RE: SEP TOPIC VI-7.C.1, INDEPENDENCE OF REDUNDANT ONSITE POWER SOURCES
(PALISADES PLANT)

EVALUATION REPORT OF SEP TOPIC VI-7.C.1
INDEPENDENCE OF REDUNDANT ONSITE POWER SOURCES
PALISADES
DOCKET NO. 50-255

FIGURE 1 SHEET 1 OF 2
SIMPLIFIED ONSITE POWER SYSTEM FOR PALISADES

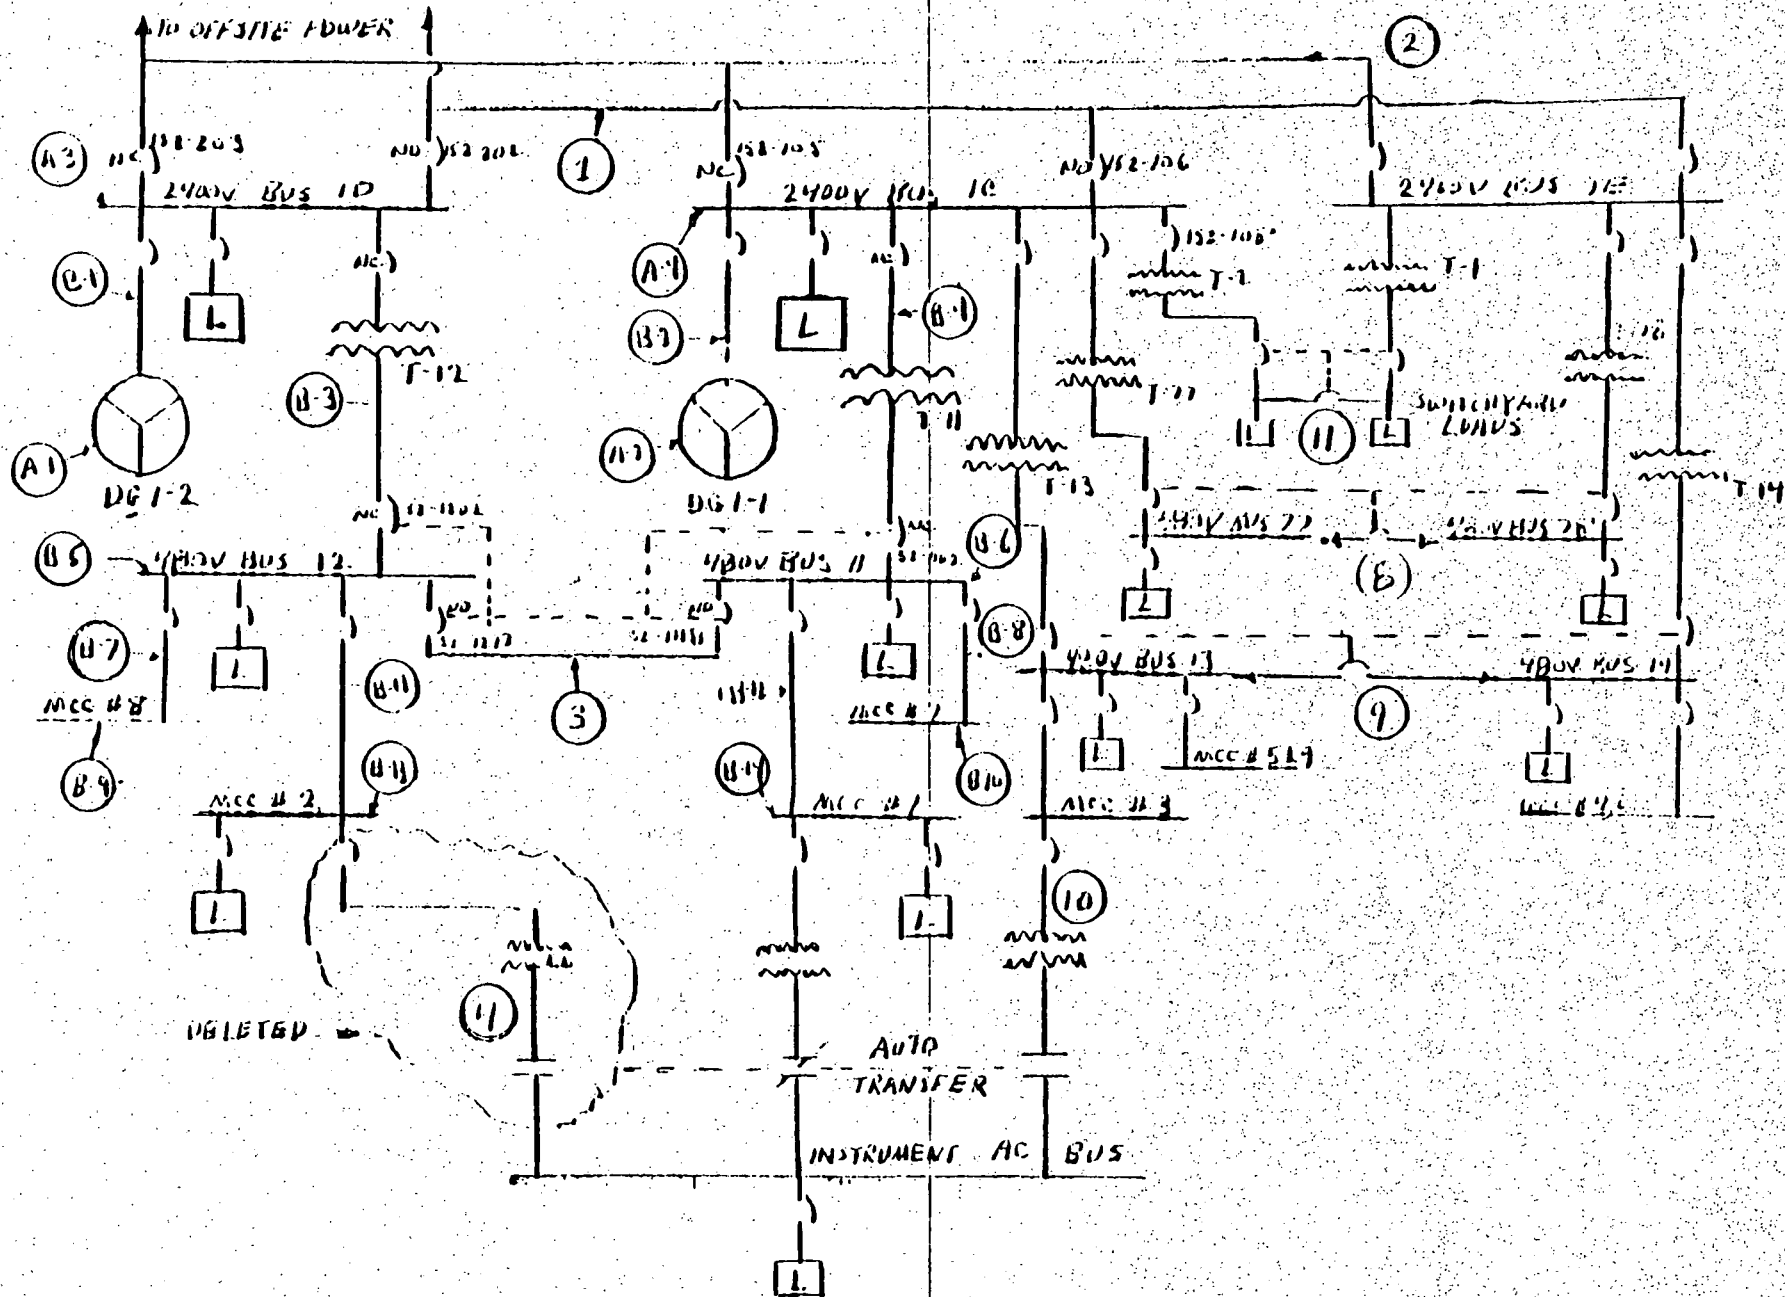
1. The 2400 V buses 1C and 1D (and, therefore, DG 1-1 and D 1-2) can be tied together only if either offsite feeder breakers 152-105 and 152-203 (normally closed) or breakers 152-106 and 152-202 (normally open) are closed. On loss of the offsite source, these breakers each receive an automatic open signal from independent low voltage sensing devices located on bus 1C for breakers 152-105 and 152-106 and on bus 1D for breakers 152-202 and 152-203. Thus, there is no single failure that can cause the interconnection of bus 1C and 1D and the paralleling of the standby onsite power sources after loss of offsite power. This meets the review criteria and guidelines defined in Section II and IV of this report.

2. See item 1.
3. The 480 V buses 11 and 12 may be tied together by closing breakers 52-1118 and 52-1217 (normally open). An interlock prevents the closure of these tie breakers if both breakers connecting the redundant sources to buses 11 and 12 (breakers 5201102 and 52-1202, respectively) are closed; one of these two supply breakers must be open in order to close the tie breakers. This meets the review criteria and guidelines defined in Section II and IV of this report.

There are no limiting conditions for plant operation when 480 volt bus 12 receives power from 2400 V bus 1C through 480 volt bus 11 or when 480 volt bus 11 receives power from 2400 V bus 1D through 480 volt bus 12. This is a deviation from review guidelines defined in section II and IV of this report. An example of an approach that could correct this deviation, would be to include the appropriate limiting conditions for operation in the Palisades Technical Specifications.

The Palisades design does not include control circuitry to open the two tie breakers automatically upon the loss of offsite power. This is a deviation from review guidelines. An example of an approach that could correct this deviation would be to install appropriately designed control circuitry to prevent possible paralleling of standby power sources, or overloading of one onsite source on loss of offsite power.

4. 480 volt motor control center number 2 (MCC #2) and MCC #1 were tied together through instrument AC bus as shown on figure 1. This interconnection was deleted on Palisades drawing E-1, Plant Single Line Diagram, Revision 1, dated March 28, 1978. The power source to the instrument AC bus was changed from MCC #2 to MCC #3. The change represents a new interconnection between MCC #1 and MCC #3. See item 10 for the evaluation of this new interconnection.

5. Each of the two battery chargers which supply power to a given 125 V DC bus, are undersized. Thus both chargers or the battery and one charger will be needed to supply the required maximum steady state DC load. Given a LOCA with simultaneous loss of offsite power, one of the two battery chargers will be automatically disconnected to maintain the independence of the two Class 1E power divisions. Also, given a single failure of a battery charger or its association AC power source, one of the two battery chargers will be lost. Present review guidelines require battery charger capacity to be sufficient to carry the maximum steady state DC loads as well as recharge the battery following an accident. The present design at Palisades is a deviation from these review guidelines. An example of an approach that could correct this deviation would be to replace two of the four battery chargers (one per division) with larger capacity battery chargers.

is possible to supply all four Preferred AC buses from the Bypass Regulator simultaneously. This is a deviation from review guidelines. An example of an approach that could correct this deviation would be to limit the number of preferred AC buses that could be simultaneously connected to the Bypass Regulator and provide limiting conditions for operation in the Technical Specifications.

8. Associated non-Class 1E 480 volt bus 77 is interconnected with non-Class 1E bus 78 by a single tie breaker. The supply breakers to bus 77 and 78 are interlocked with the tie breaker such that one of the two supply breakers must be open to close the tie breaker. Thus, Class 1E bus 1C cannot be paralleled with non-Class 1E bus 1E through bus 77 and 78. Also, the load breaker on bus 1C opens on loss of offsite power to prevent diesel generator 1-1 overload. This meets the review guidelines.

9. The interconnection between 480v bus 13 and 480v bus 14 is the same as item 8 evaluation.
10. Division 1 Class 1E MCC #1 is interconnected with non-Class 1E MCC #3 through an auto transfer switch via the instrument AC bus. Power to the instrument AC bus is normally supplied by MCC #1. With loss of MCC #1 the power source is automatically transferred from MCC #1 to MCC #3. Because MCC #3 is non-Class 1 and is not interconnected with MCC #2 (MCC #1's redundant counterpart), this design meets the review guidelines.

11. Two associated non-Class 1E 480 volt busses for switchyard loads are interconnected by a single tie breaker. The supply breakers to these busses are interlocked with tie breaker such that one of the two supply breakers must be open to close the tie breaker. Thus, Class 1E bus 1C cannot be paralleled with non-Class 1E busses. The evaluation of item 8 applies to this design.

- (A) Each of the following items are located in a dedicated room or are separated by the equivalent of a three-hour rated fire barrier from their redundant counterpart or from components associated with their redundant counterpart. This meets the review criteria and guidelines defined in Section II and IV of this report.

(B) Each of the following items are located in the general area of their redundant counterparts or in the area of components associated with their redundant counterparts. The separation between components is less than the equivalent of a three-hour rated fire barrier. This is a deviation from Section 9.5.1 review guidelines defined in Section IV of this report. Refer to the Palisades fire hazards analysis, the NRC Palisades Fire Protection Safety Evaluation Report, and any supplements thereto for identification of compliance to, deviation from, and corrective design measures required for deviations from those review guidelines.

For the above listed cables and for instrumentation and control cables associated with the Class 1E power distribution system components, the separation is less than the 5 ft. vertical 3 ft. horizontal recommended by Regulatory Guide 1.75. This is a deviation from the review guidelines. An example of an approach that could correct this deviation would be to perform an analysis for the above defined cables to identify the specific deviations from the recommendations of Regulatory Guide 1.75. For each specific deviation identified, corrective measures such as installation of barriers, rerouting of redundant cables, or supplemental analyses justifying the existing separation on some other defined basis are acceptable approaches to removing this deviation.
